**SOIL, GEOLOGY, AND GEOLOGIC HAZARD STUDY
COPPER CHASE AND STERLING RANCH FILING NO. 2
EL PASO COUNTY, COLORADO**

February 10, 2020
Revised September 25, 2020
Revised March 18, 2021

APPENDIX F: Colorado Geological Survey (CGS) Comments, July, 9, 2020

APPENDIX G: Colorado Geological Survey (CGS) Comments, March, 10, 2021

TEST BORING LOCATION MAP
Copper Chase & Sterling Ranch R2
EL PASO, COLORADO
FOR: MORLEY-BENTLY INVESTMENTS

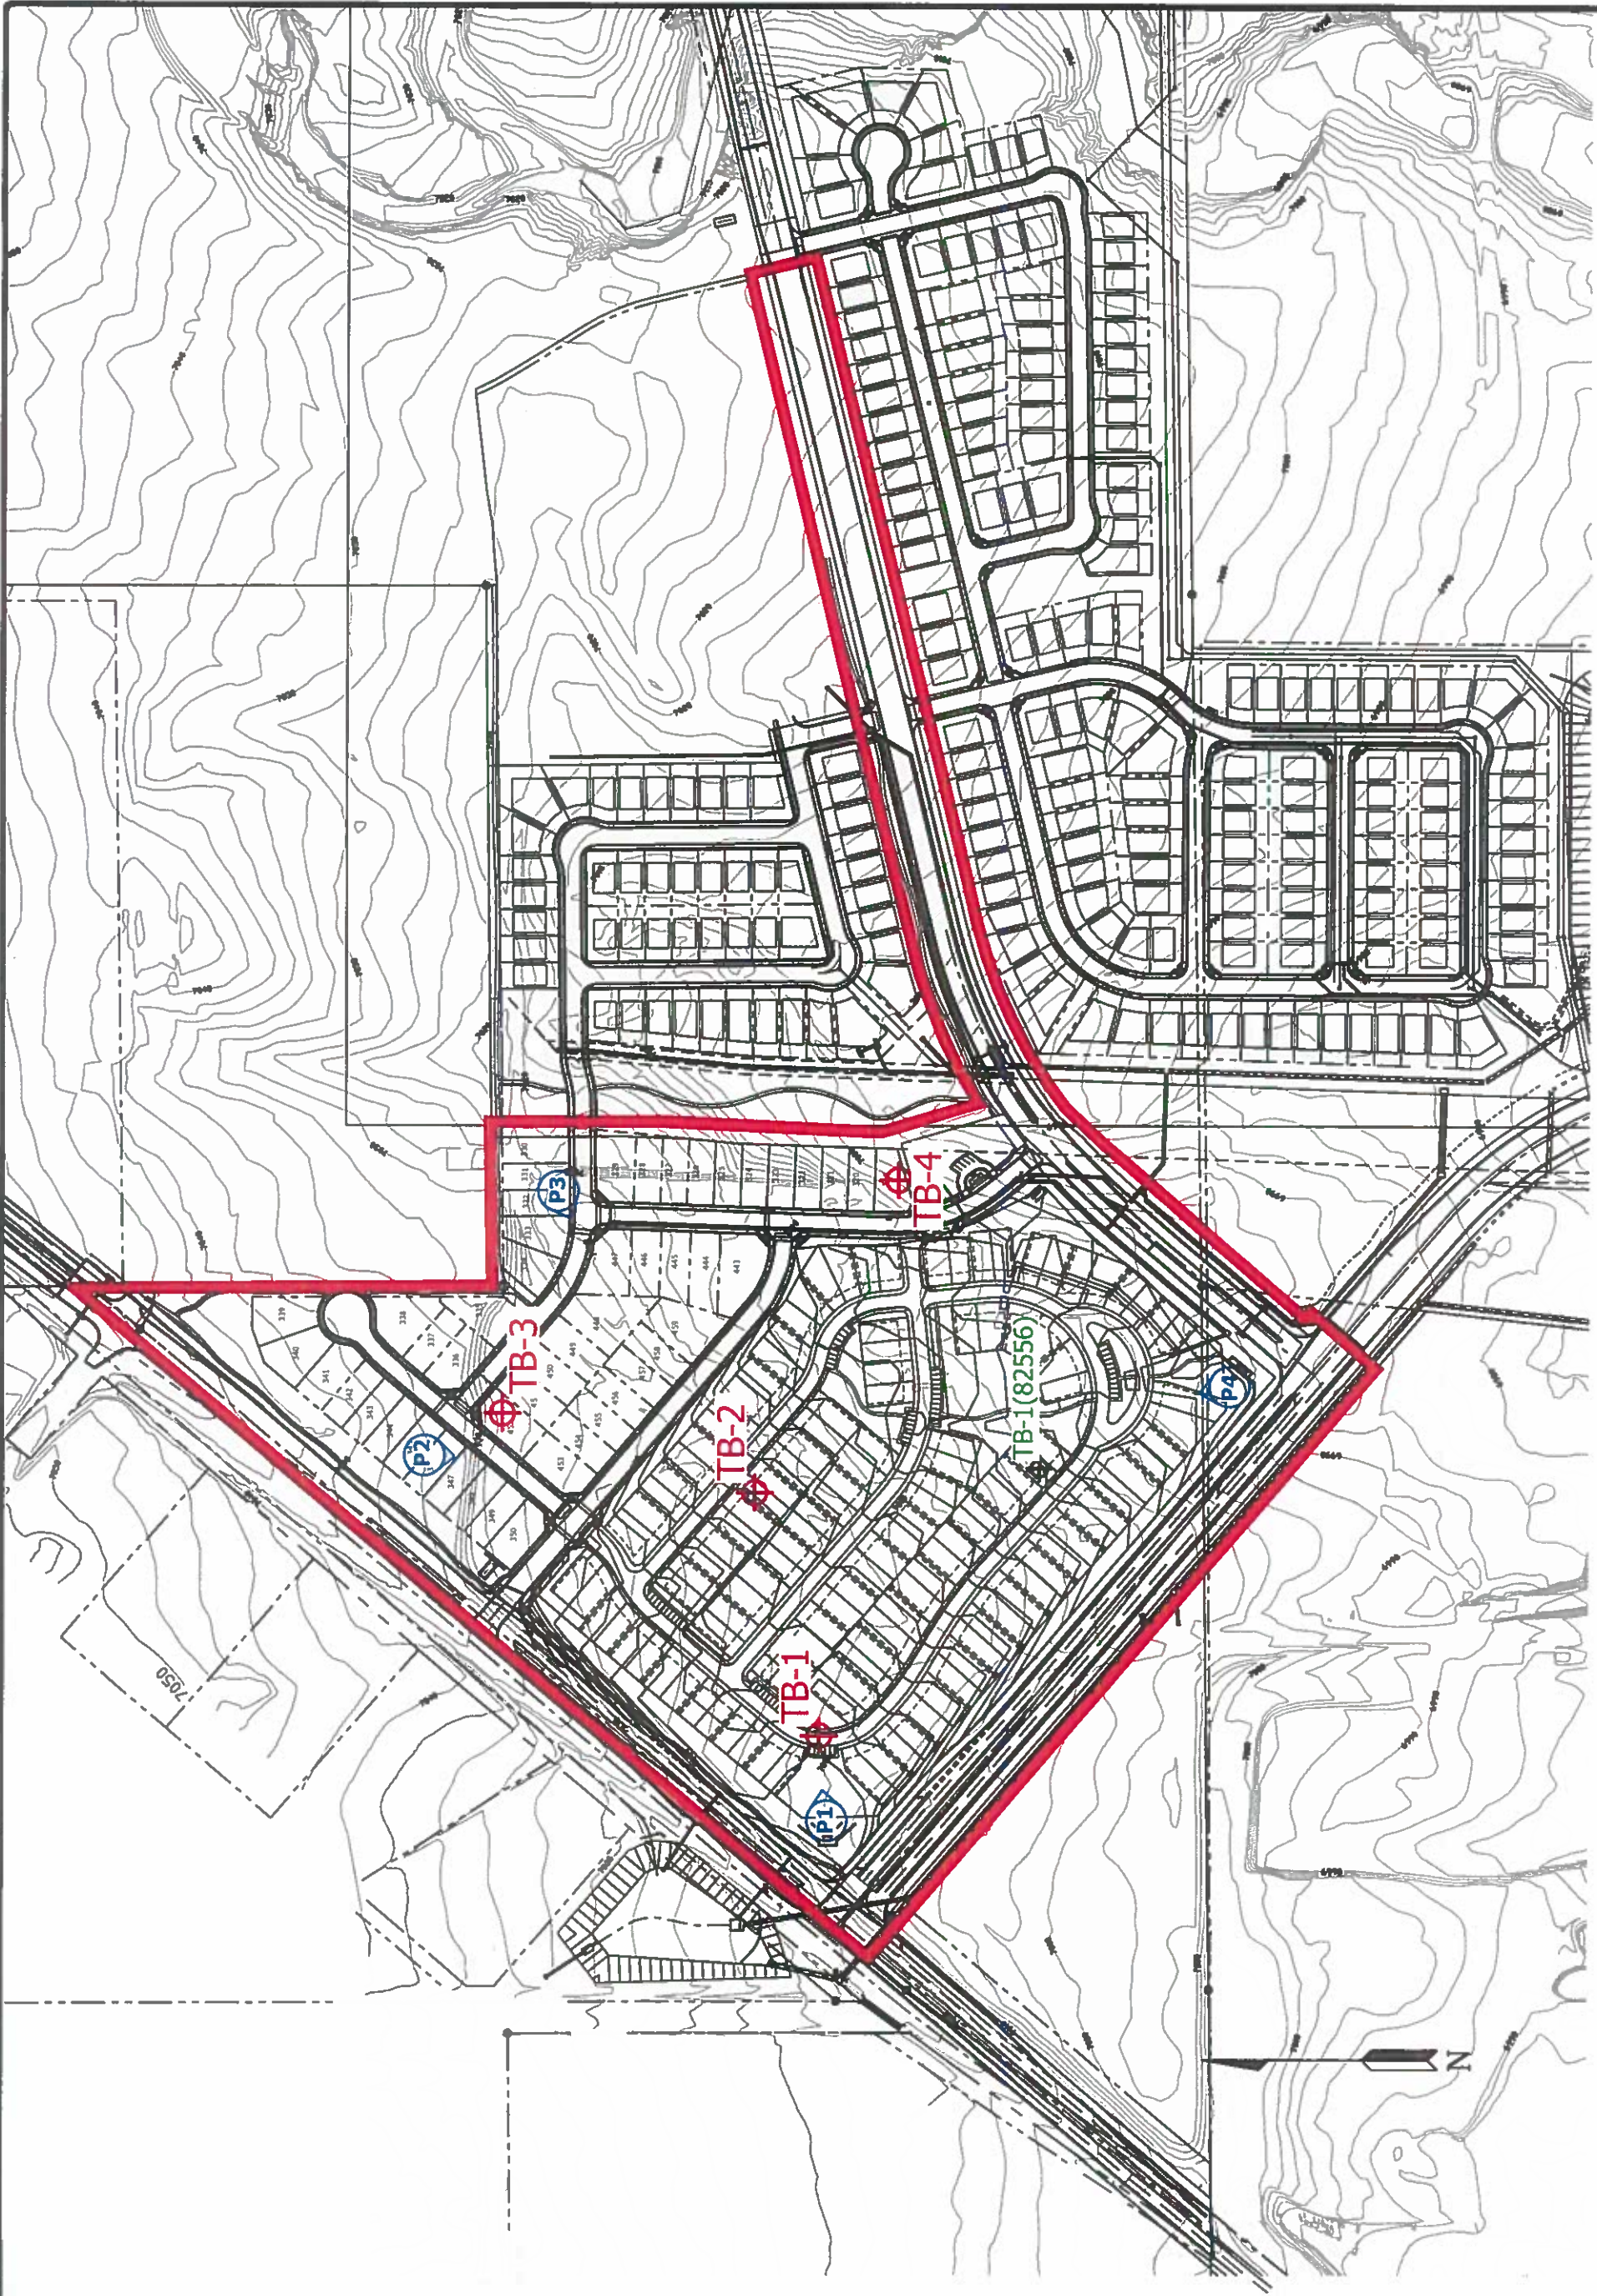
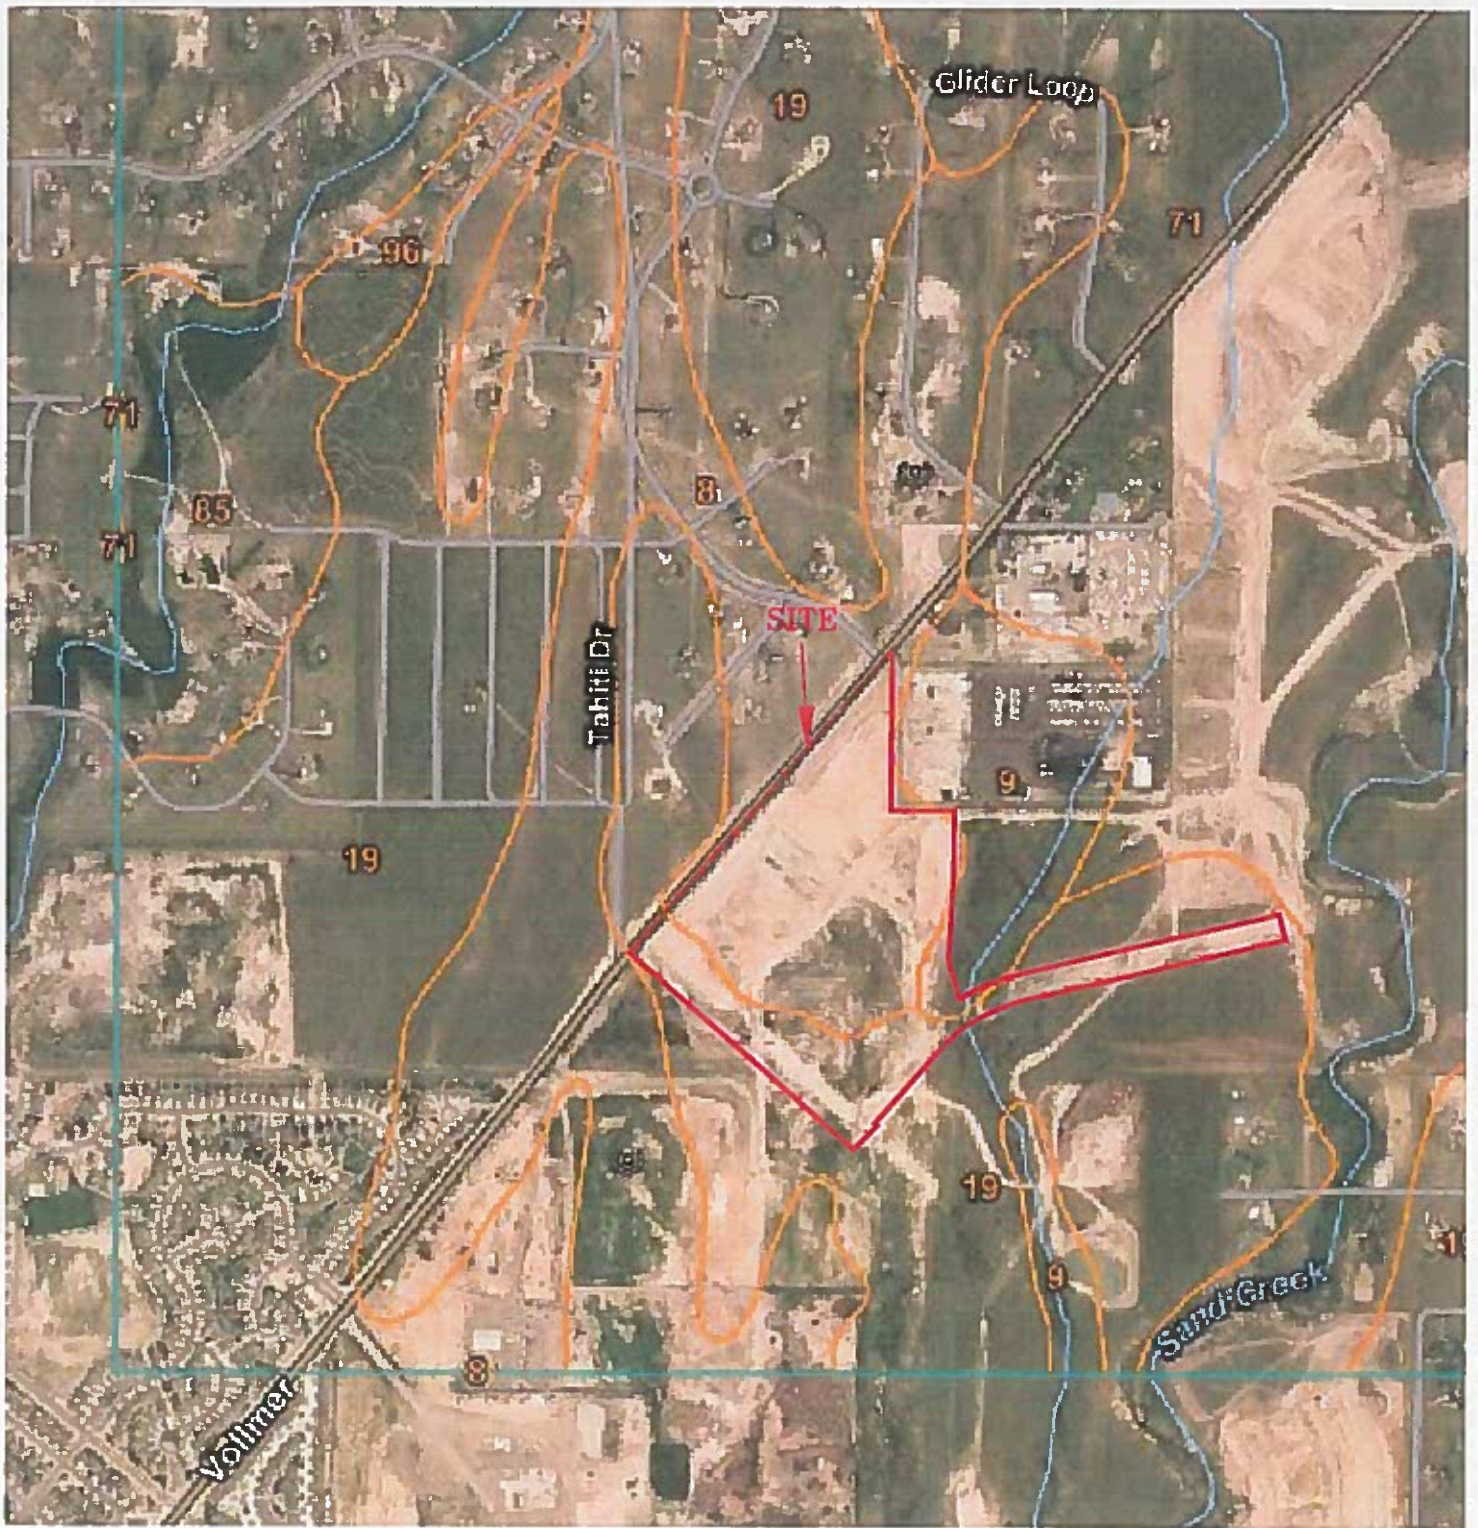
2) Entech's Figures 4 and 7 show two locations labelled TB-1. One of these borings appears to be from a 2006 Entech investigation, and should be identified as such on the figures.

GEOLOGY/ENGINEERING GEOLOGY MAP
 COPPER CHASE & STERLING RANCH
 FIGURE 2
 EL PASO, COLORADO
 FOR: MORLEY-BENTLY INVESTMENTS

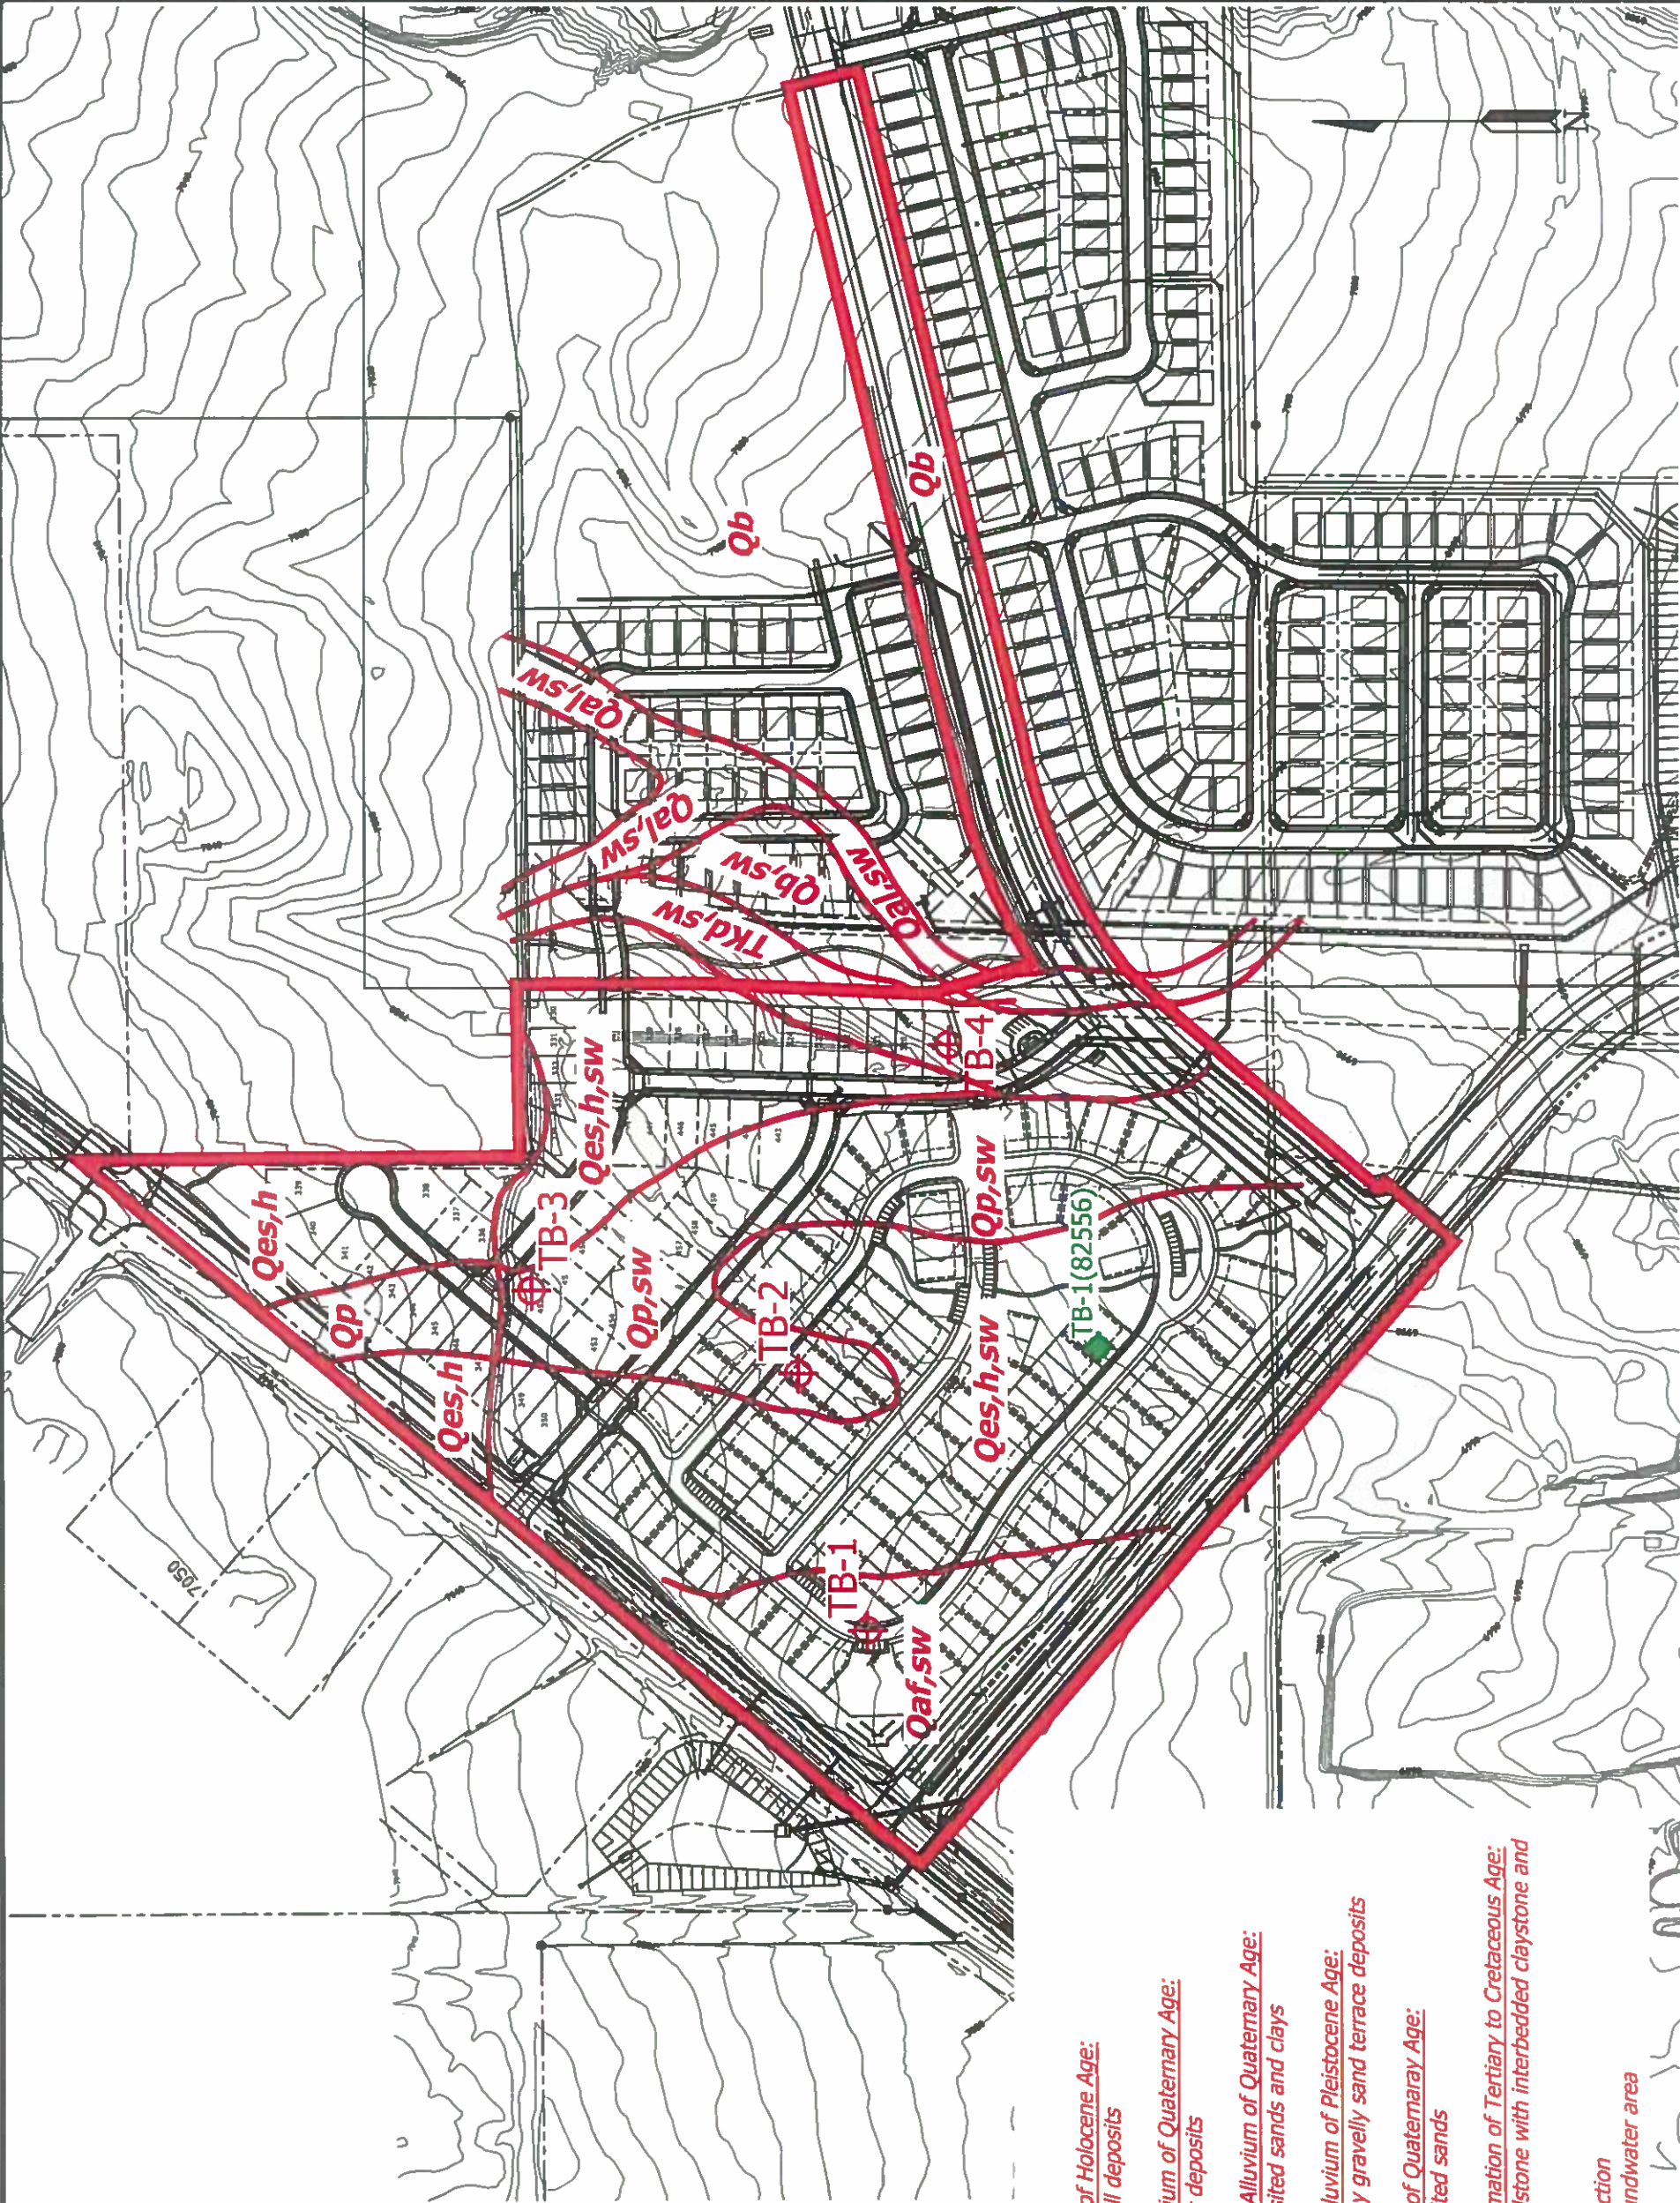
2. Entech's Figure 7 (mis-identified as Figure 2 in the title block) designates all previously identified "potentially seasonal shallow groundwater" areas as "seasonal shallow groundwater" areas.

1. Entech's water level data do not support their characterization of the site's shallow groundwater condition as "seasonal." Entech's Figure 7, plat note 26 on sheet 2, and sheet 7 of the plat should be corrected to identify the entire Sterling Ranch Filing No. 2 (Phase 1) site as a shallow groundwater area.
